**Regular Council - Land Use Meeting
B.2 7923-0223-00
Monday March 10, 2025**

**RE: Agenda Item B.2, March 10, 2025 Regular Council – Land Use
Development Application No. 7923-0223-00
Replacement Pages for the Planning Report**

After finalizing the Planning Report for the March 10, 2025 Regular Council – Land Use Agenda, it was noticed that 4 lots require a DVP for lot depth, and only 2 of them were listed on the report.

Pages 2, 4, 12 and Appendix VIII of the Planning Report have been updated to reflect this change.

PRELIMINARY SUBDIVISION PLAN OF
LOT 1, PLAN 64957;
LOT 3, PLAN 65771;
LOT 6 EXCEPT PART SUBDIVIDED BY PLAN 64957,
LOT 8 EXCEPT PART SUBDIVIDED BY PLAN 65771
AND LOT 9, PLAN 30171; ALL SECTION 17 TOWNSHIP 7
NEW WESTMINSTER DISTRICT

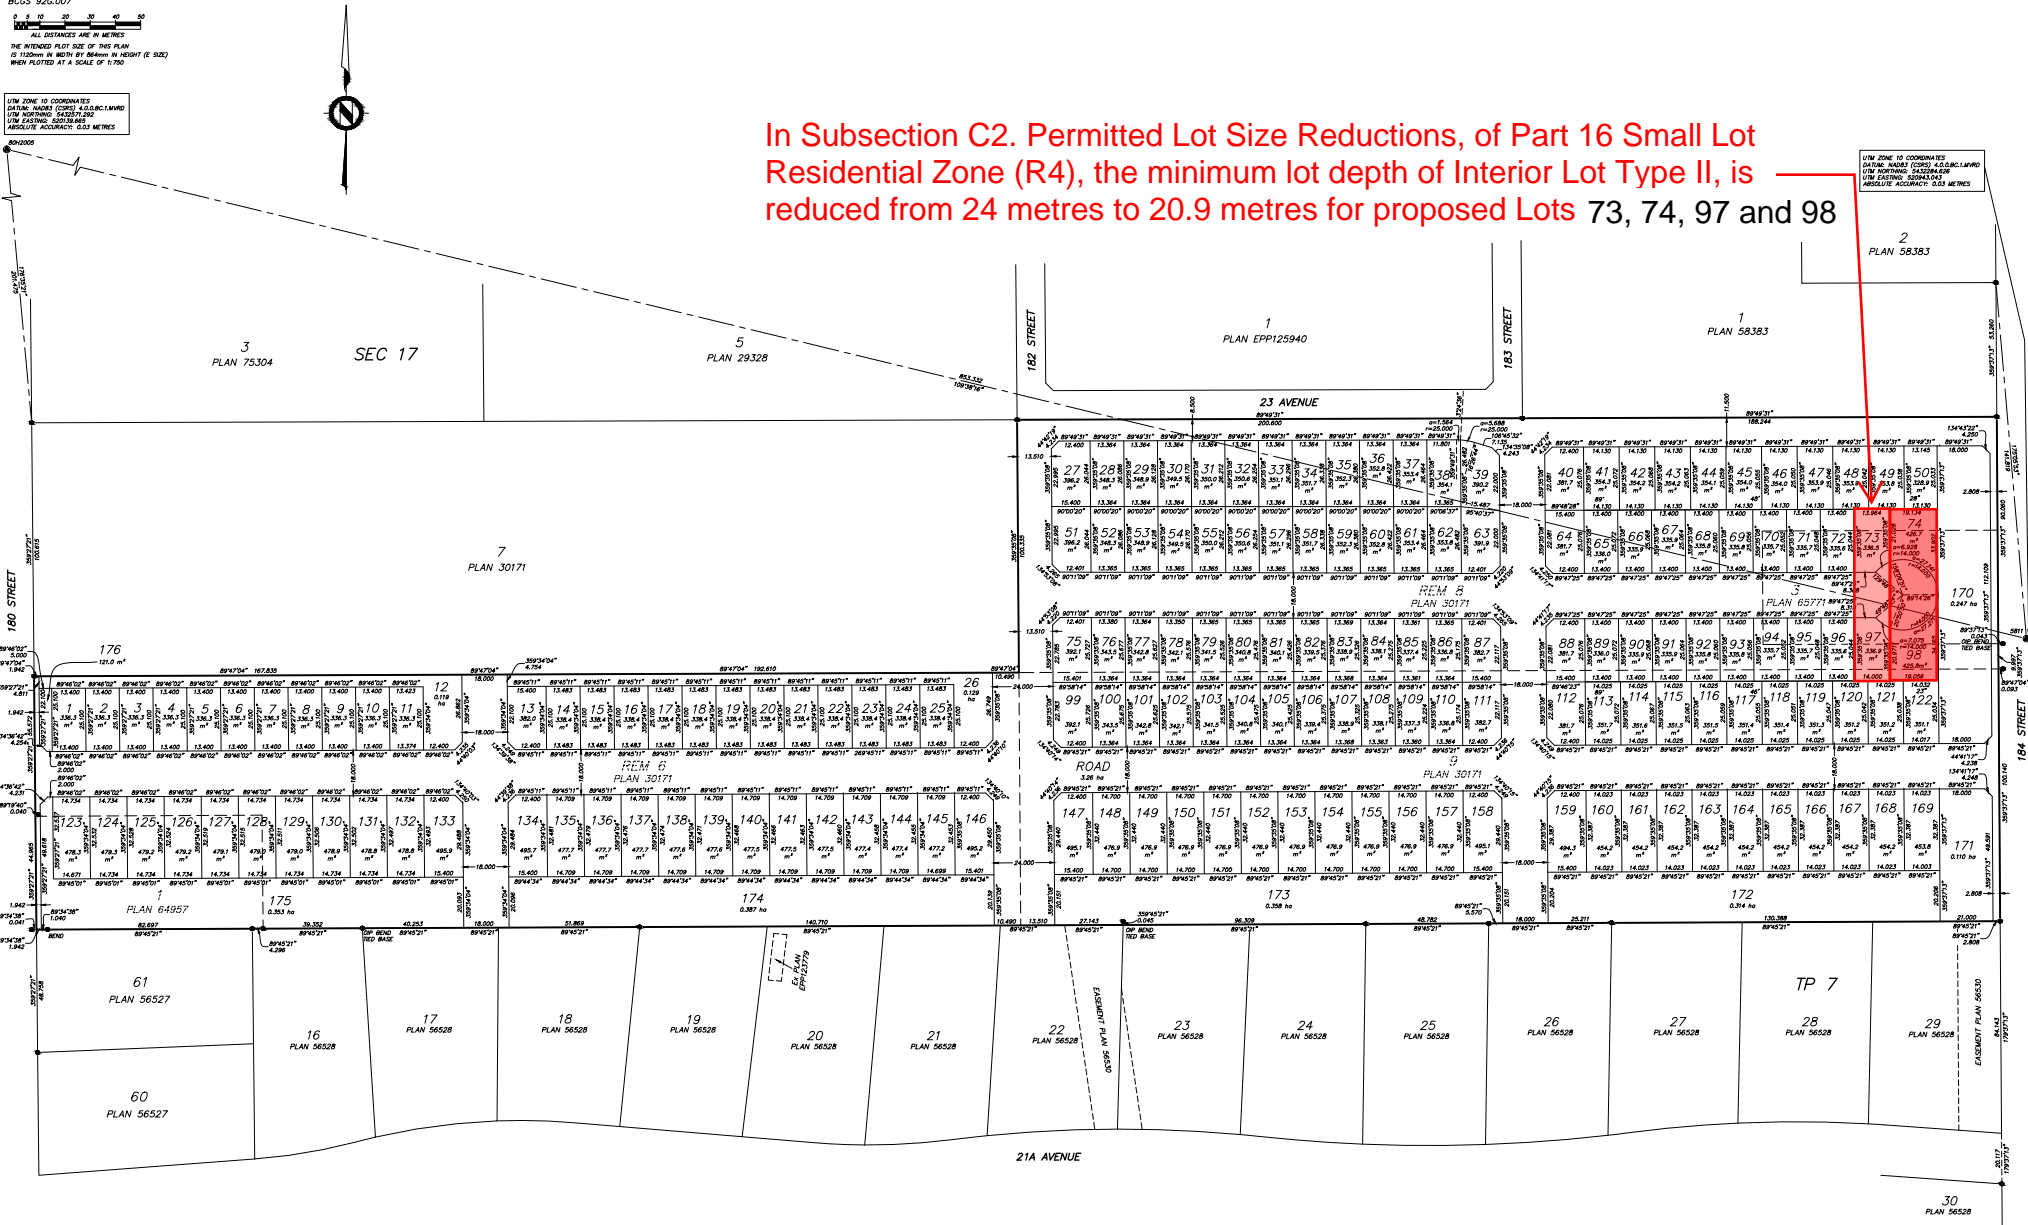
In Subsection C2, Permitted Lot Size Reductions, of Part 16 Small Lot Residential Zone (R4), the minimum lot depth of Interior Lot Type II, is reduced from 24 metres to 20.9 metres for proposed Lots 73, 74, 97 and 98

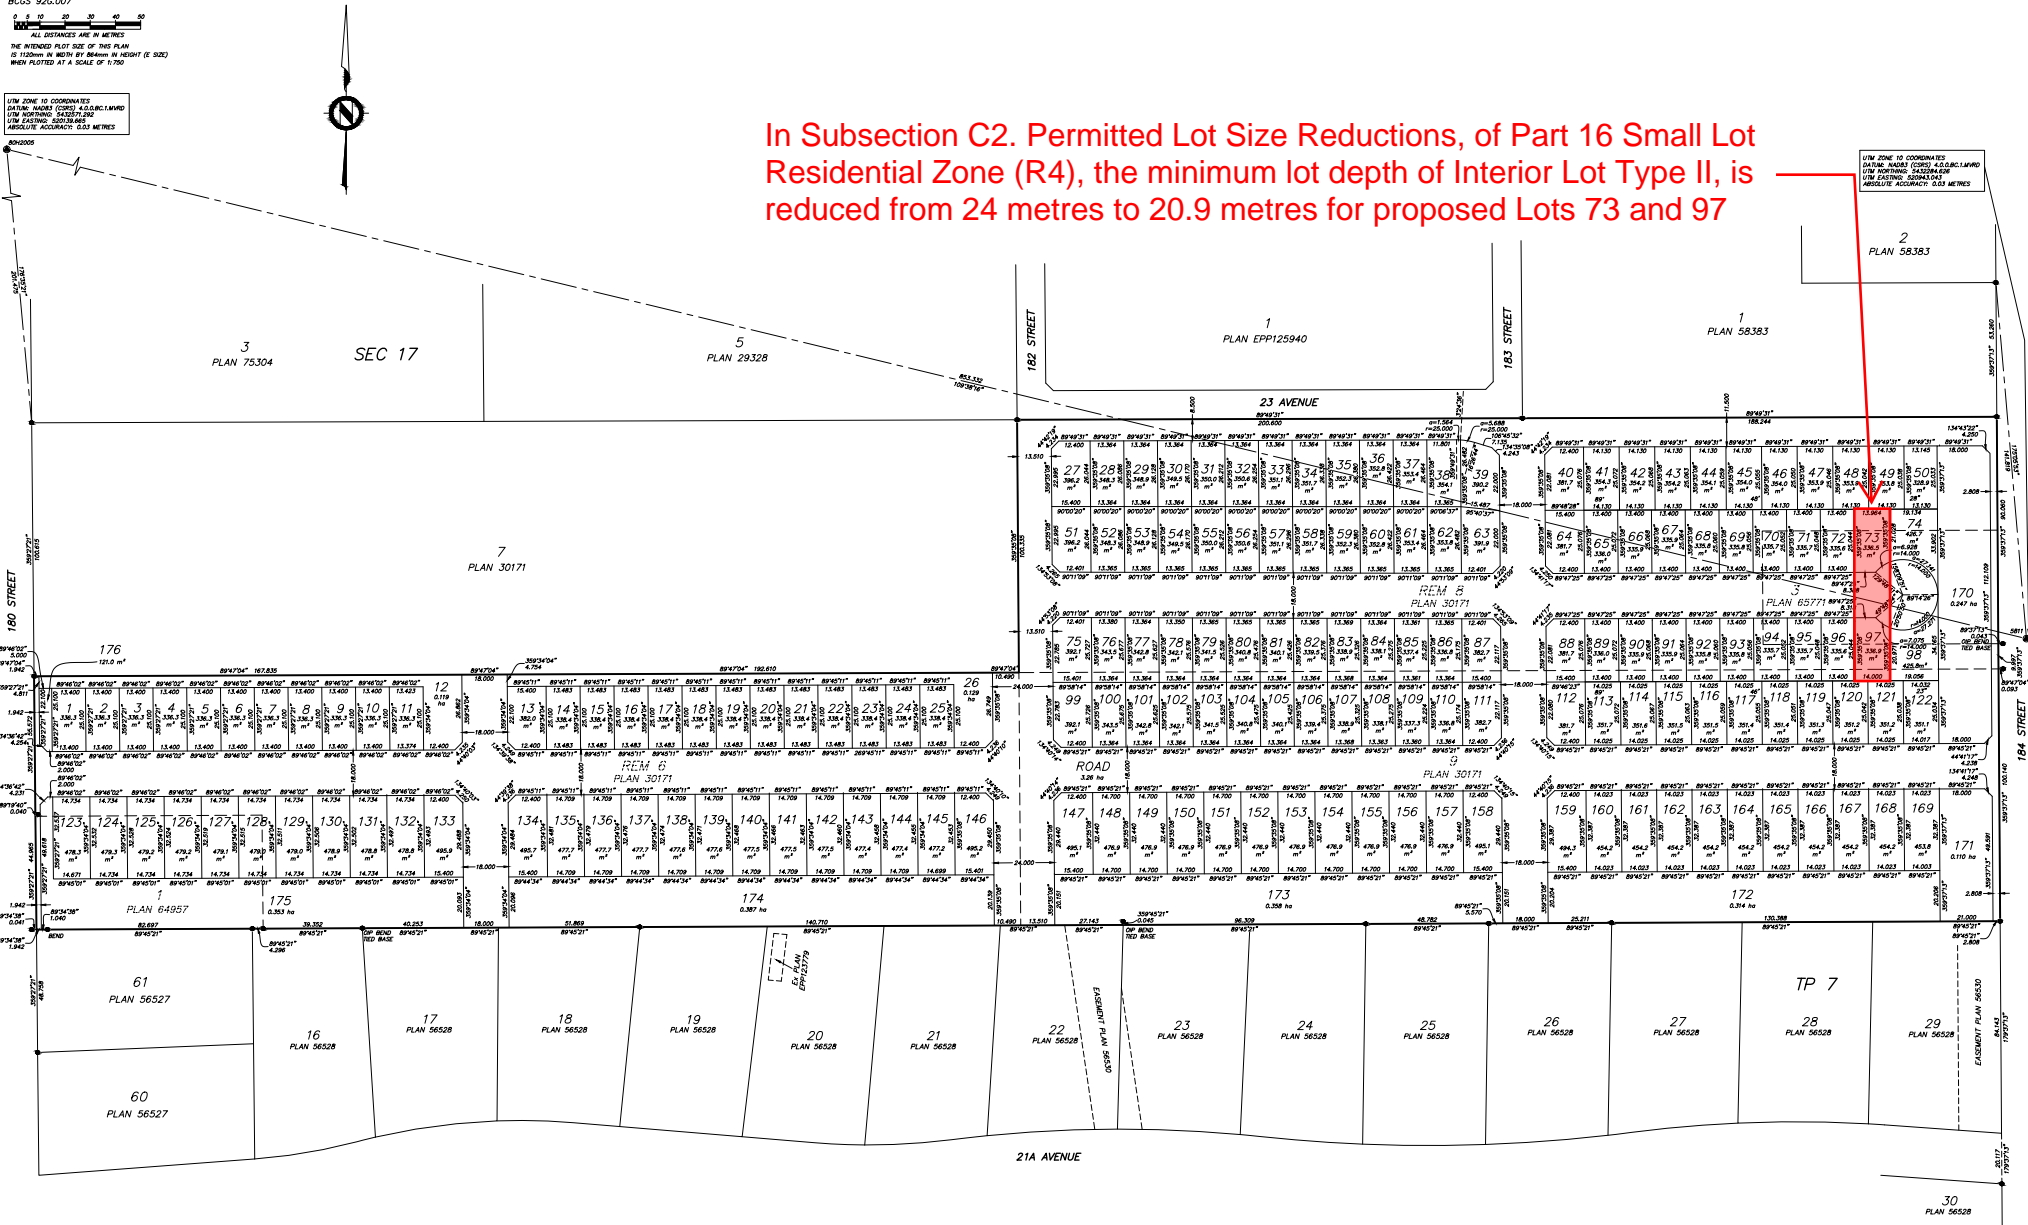
In Subsection C2. Permitted Lot Size Reductions, of Part 16 Small Lot Residential Zone (R4), the minimum lot depth of Interior Lot Type II, is reduced from 24 metres to 20.9 metres for proposed Lots 73 and 97
